REMARKS

U.S. Serial No.: 10,784,421
Inventor: Paul D. Verhagen
Title: System For Reducing Noise From A
Thermocouple In An Induction Heating System
Docket No.: ITWO:0020-1(13222.01) /YOD

FIG. 6

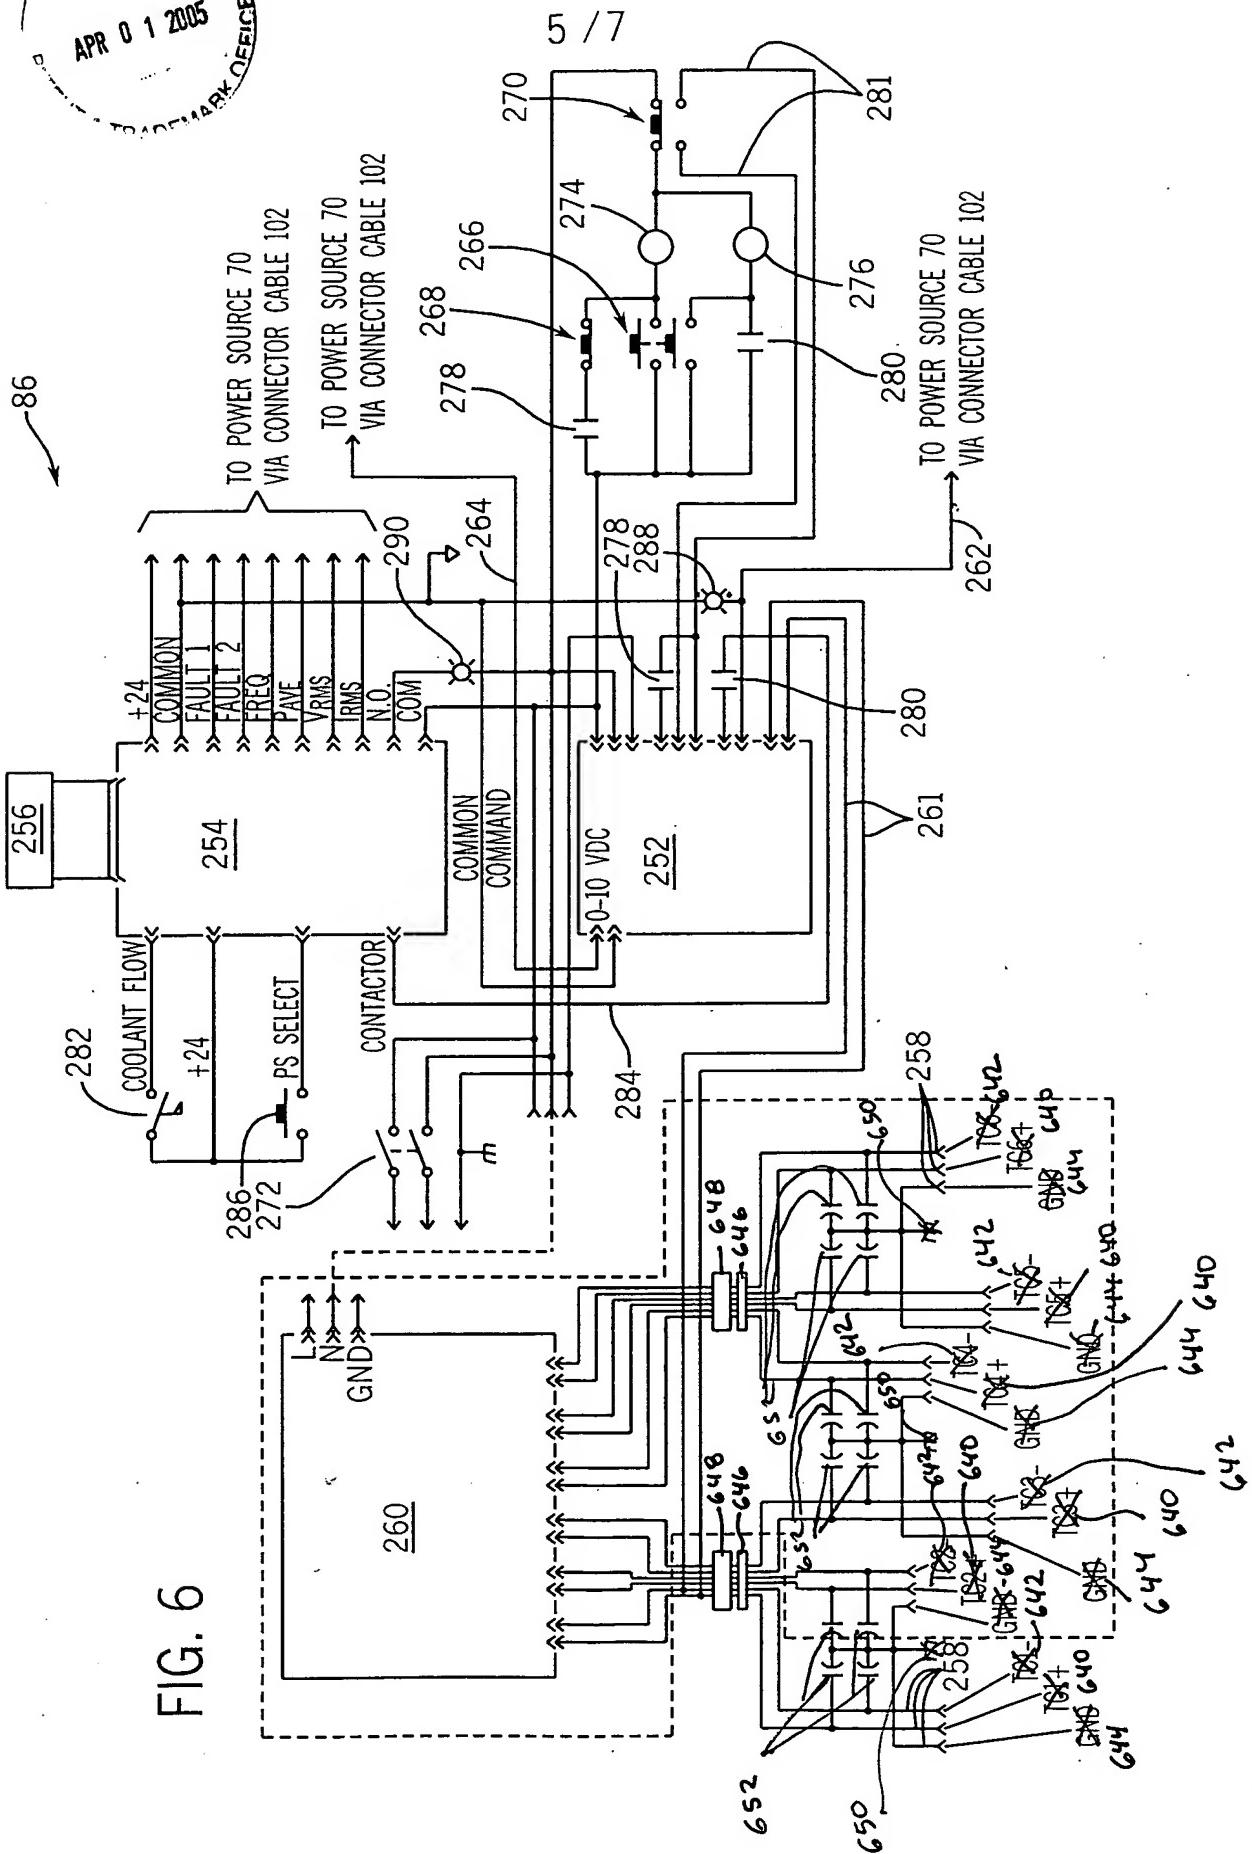
Secondly, Applicant respectfully directs the Examiner's attention to FIG. 6 of the present application as an example of the descriptive support for the recitation "interface circuit" in the present application. This figure illustrates an electrical schematic of a controller according to an exemplary embodiment. As described in the present application, FIG. 6 illustrates control circuitry 86 that includes jacks 258 that enable a temperature feedback device 60 to be electrically coupled to a controller 72 and to a data recorder 60. *See Application, p. 11, ll. 11-21.* And, as is best illustrated in FIG. 6, certain of these jacks 258 are electrically coupled to ground via a capacitor, which, as would be appreciated by one of ordinary skill in the art, is symbolically represented as "| (".

In the Office Action, both the drawings and the specification were objected to for failing to conform with one another. Specifically, the fact that the figures did not illustrate reference numerals 640, 642, 644, 646, 648, 650, and 652 that are identified in the specification were objected to.

By the present Response, Applicant has amended FIG. 6 to include these reference numerals. With respect to these amendments, Applicant asserts that no new matter has been added. As discussed above, FIG. 6 is textually described in the Specification of the present application. *See Application, p. 5, ll. 1-2; p. 11, l. 11 to p. 16, l. 7; p. 18, l. 18 to p. 20, l. 3.* This description, taken in conjunction with the symbolic representations on FIG. 6 itself (e.g., the use of "| (" to represent a capacitor and "GND" for ground),

demonstrate that adding reference numerals to the already described components of FIG. 6 does not constitute the addition of new matter.

By the present Response, Applicant has amended the Figures. Specifically, Applicant has amended various reference numerals in FIGS. 6, 8, and 9 of the present application. These amendments are shown in red ink on the Amended Sheets provided herewith. Additionally, Applicant provides herewith Replacement Sheets that replace Figure Sheets 5 and 7 of the present application.
